ANCHOR BOLT SETTING PLAN
(BOTTOM OF BASE PLATE ELEVATION: (-1'-10") (U.N.O)
(REF:S1.1)

07/24/2020			ISSUE FOR APPROVAL
DATE	NO.		DESCRIPTION
REVISIONS

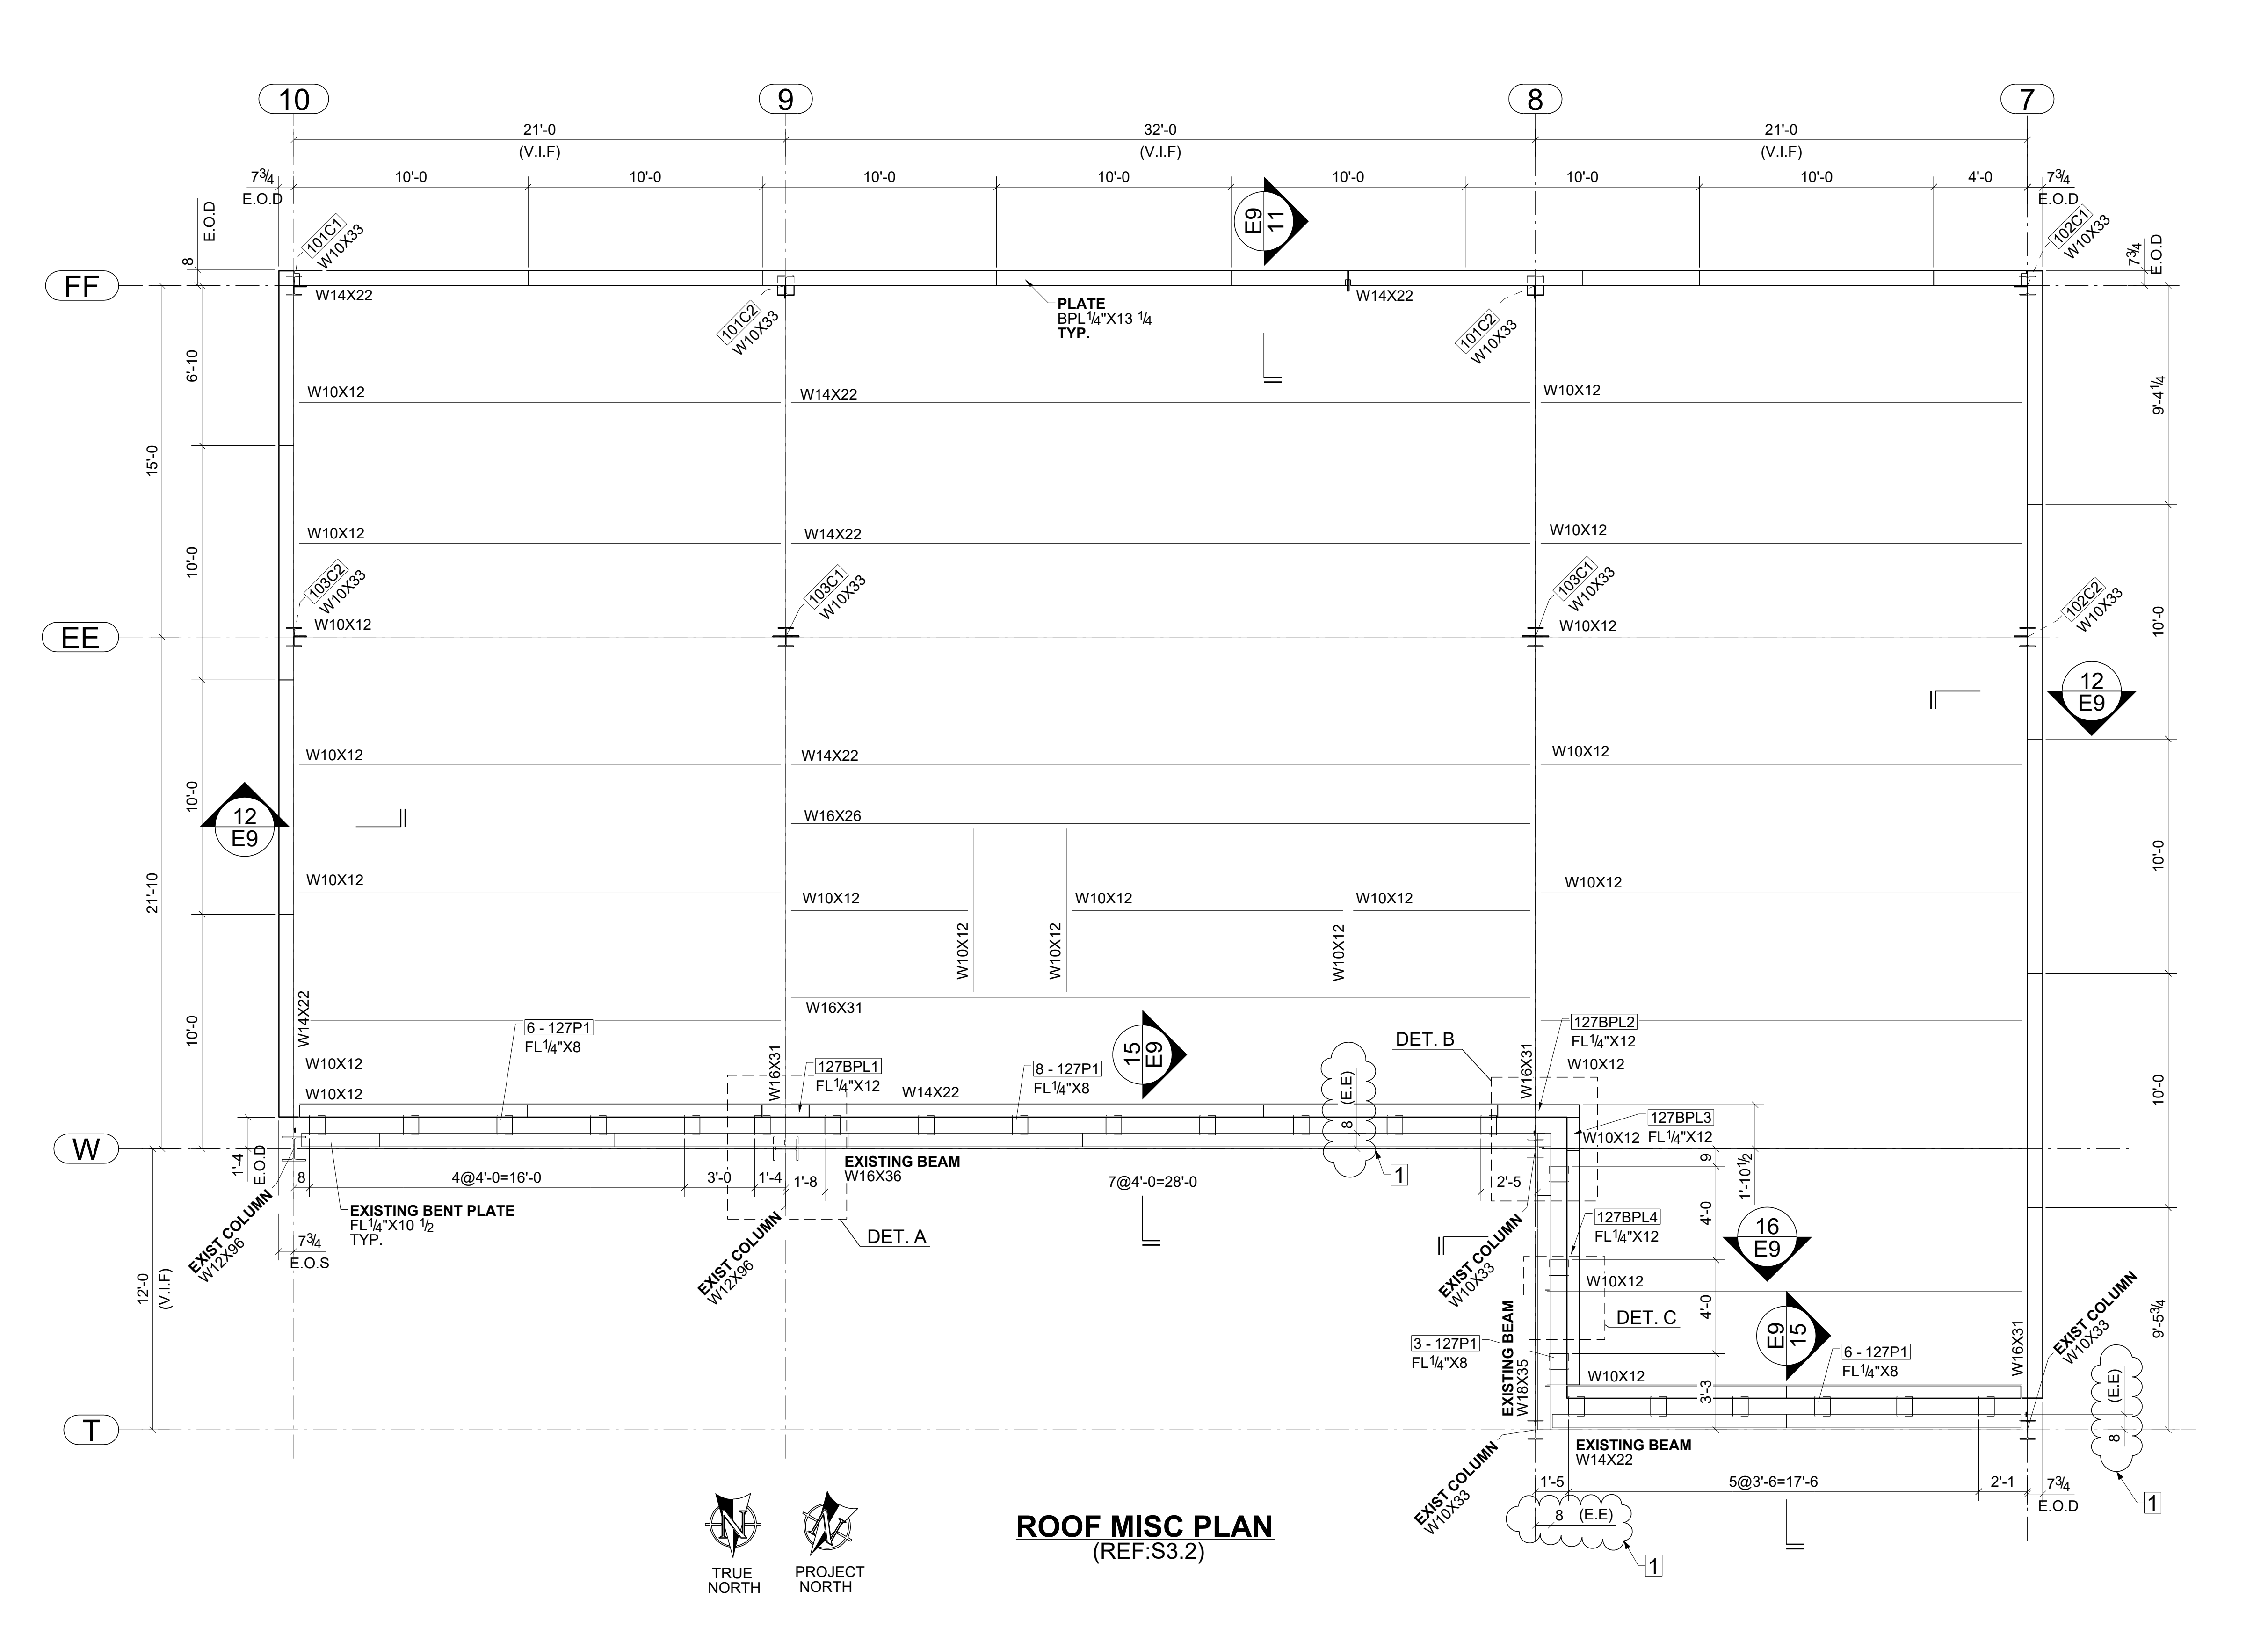
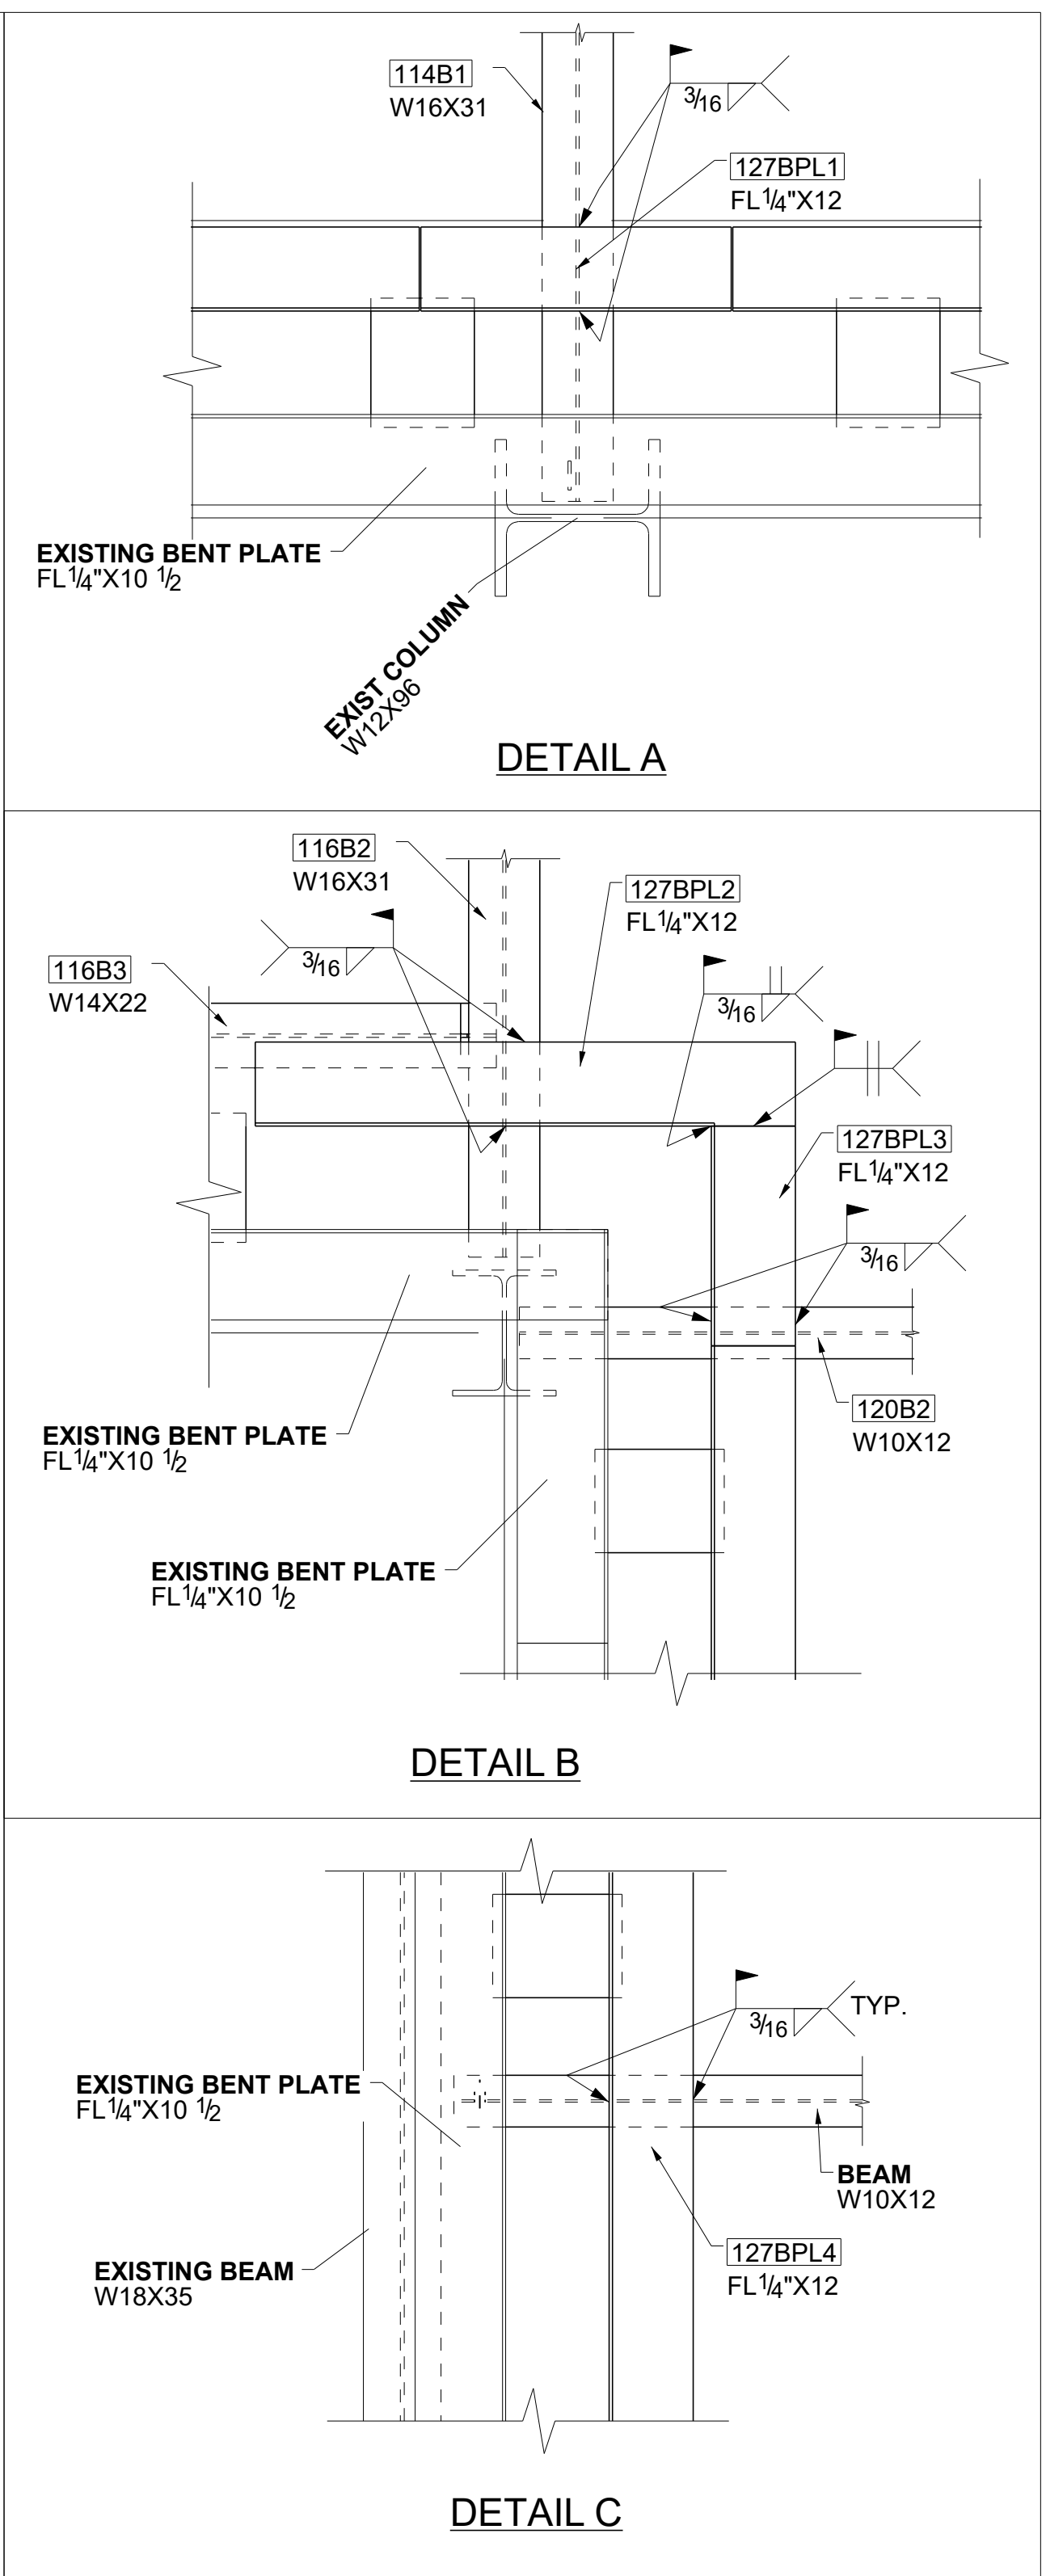
APPROVER NOTE:
1 PLEASE REVIEW AND CONFIRM THE CLOUDED 8" EXISTING E.O.D DIMENSIONS FOLLOWED.
